CERTIFICATE OF APPROPRIATENESS

Property: 744 Harvard Street, Lot 23, Block 259, Houston Heights Subdivision. The property includes a historic 1,300 square foot one-story wood frame single-family residence and a detached garage situated on a 6,600 square foot (50' x 132') interior lot.

Proposal: Alteration – Addition. The applicant is proposing to construct a 975 square foot addition, bringing the total square footage of the house to 2309 SF.

☒ ☐ ☐Side Setbacks (Addition and New Construction)

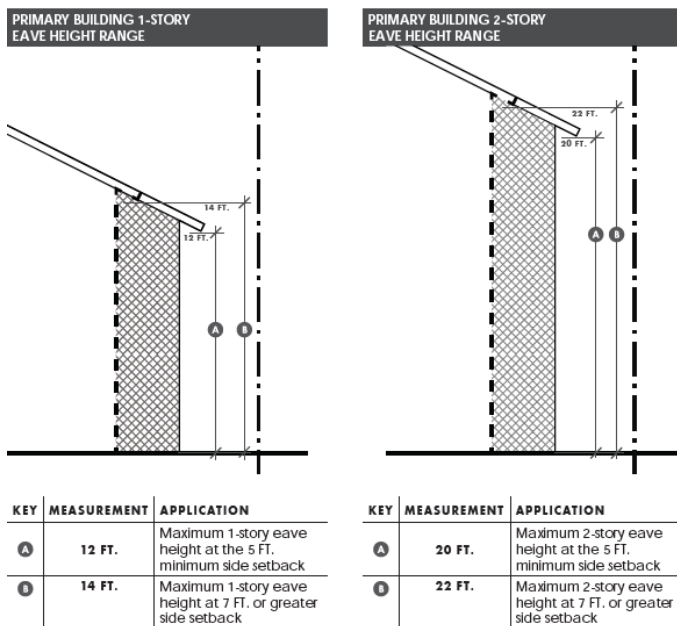
Proposed side setback (south elevation): 9'-9"
 Proposed side setback (north elevation): 7'- 1 1/4"
 Cumulative side setback: 16'-10 1/4"

☒ ☐ ☐Building Wall (Plate) Height (Addition and New Construction)

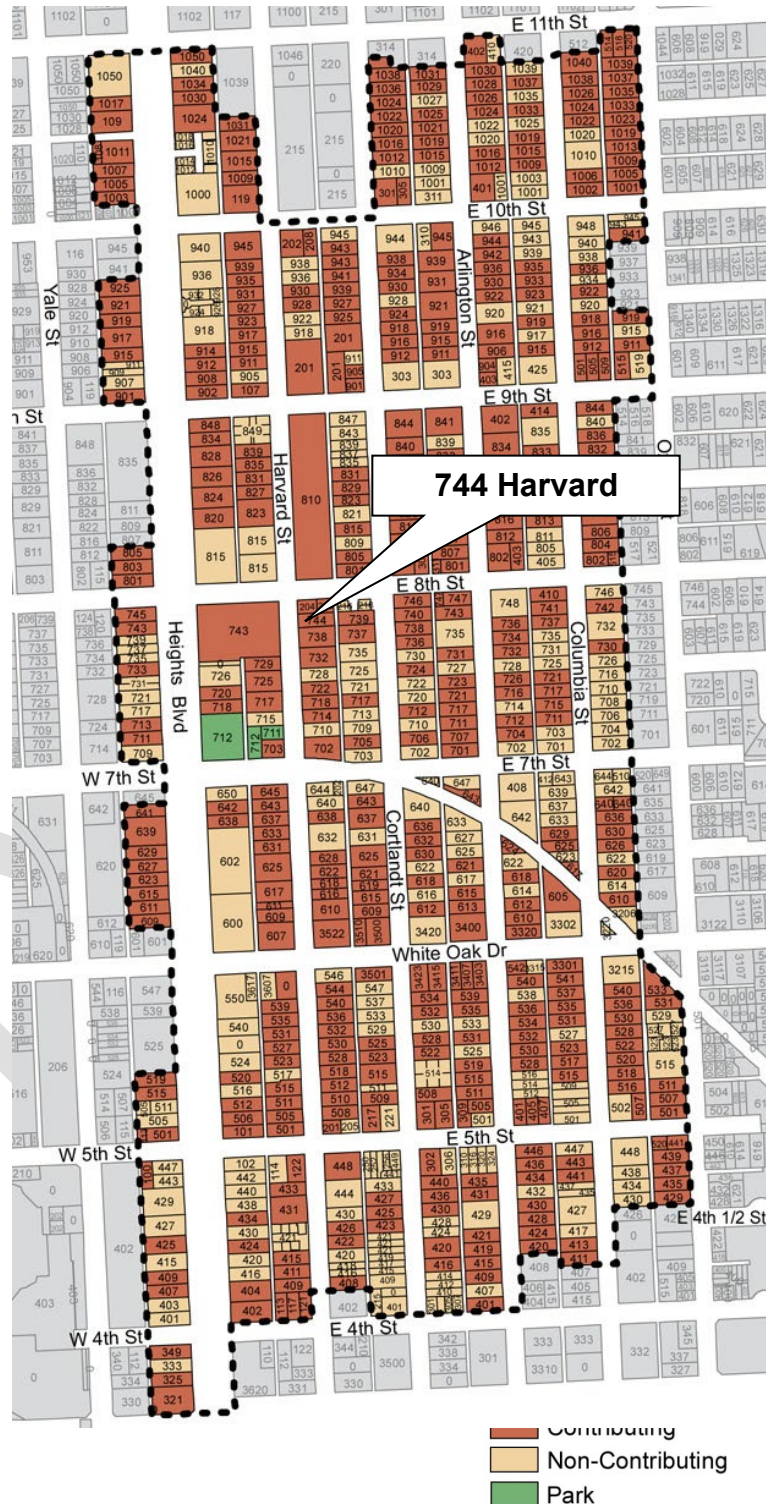
Proposed finished floor: 27 1/2"

Proposed first floor plate height: 9'2"

Proposed second floor plate height 6'-8"

Historic Window Standard: New Construction & Replacement

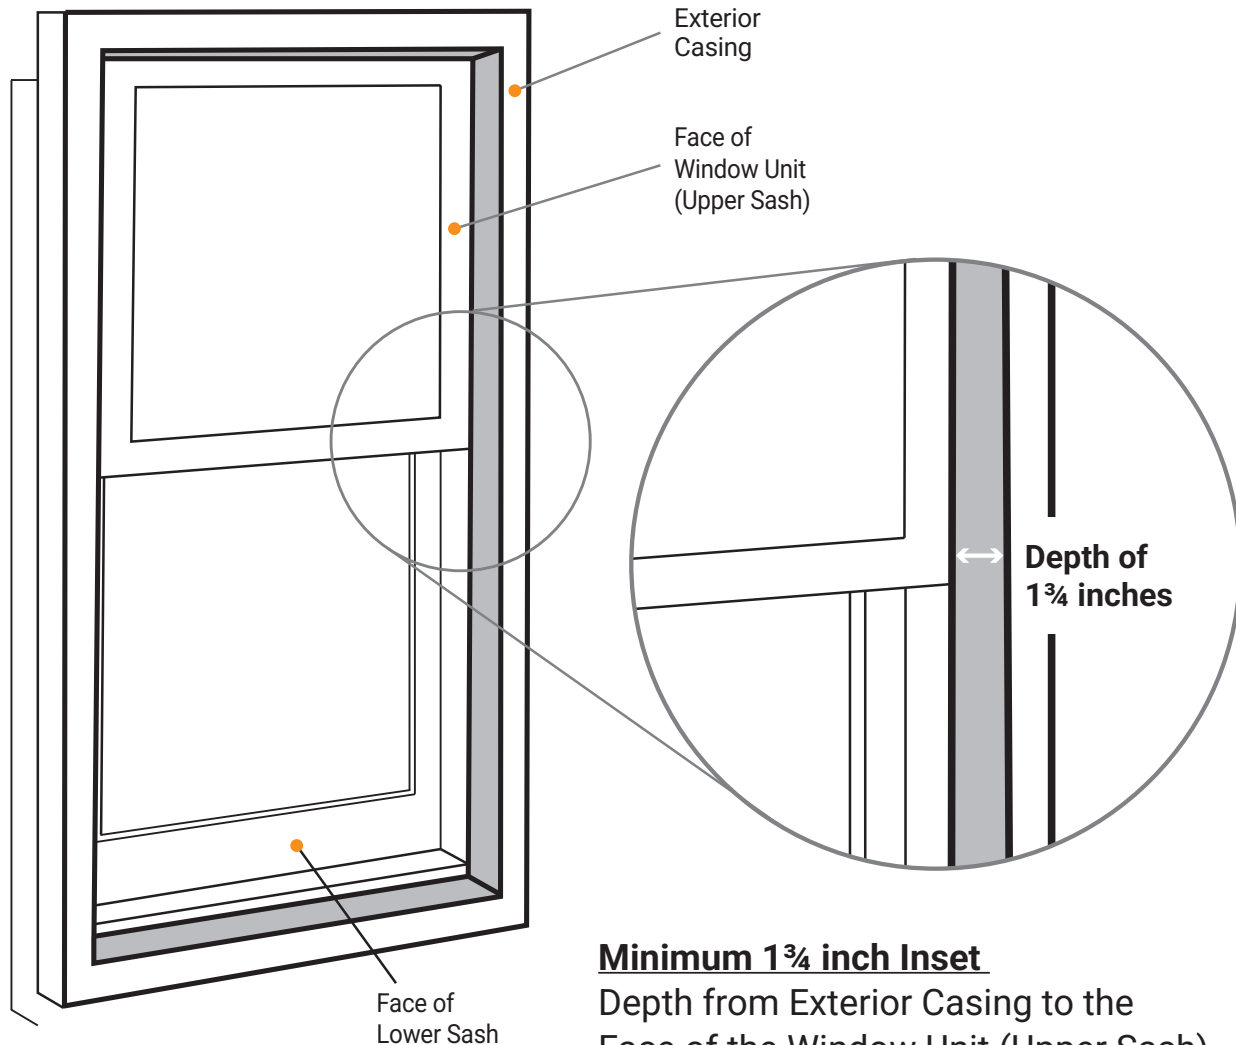
Minimum 1 3/4 inch Inset

Depth from Exterior Casing to the Face of the Window Unit (Upper Sash)

Windows must be 1-over-1
(equally horizontally divided)

1 3/4 inch minimum inset for Fixed Window
